APPENDIX L – SAFETY EVALUATION OF SUPPLEMENT 4 TO NEDO-33173

FINAL SAFETY EVALUATION BY THE OFFICE OF NUCLEAR REACTOR REGULATION

NEDO-33173, SUPPLEMENT 4

“IMPLEMENTATION OF PRIME MODELS AND DATA IN DOWNSTREAM METHODS”

Figure 1: ECCS/LOCA Evaluation Model Process Diagram (Reference 8)

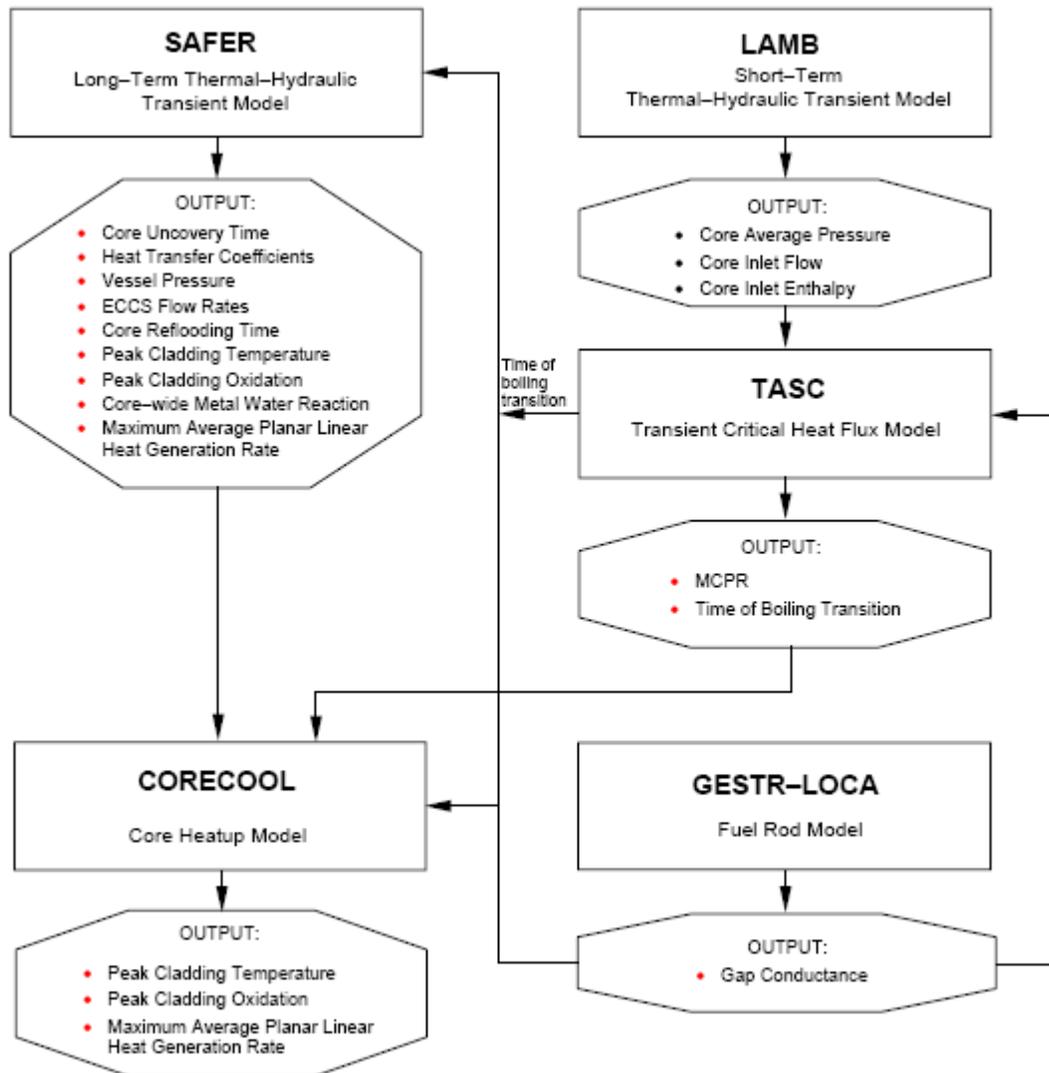
The basis for the Appendix K ECCS/LOCA evaluation model is SAFER/GESTR (Reference 1). The purpose of the SAFER code is to calculate long-term reactor vessel inventory and PCT for LOCA and loss of inventory events. SAFER is intended for use with GSTRM to perform ECCS/LOCA analyses. The various individual codes utilized in the ECCS/LOCA evaluation model are depicted in Figure 1. The GESTR-LOCA fuel rod model mentioned in Figure 1 is equivalent to GSTRM.
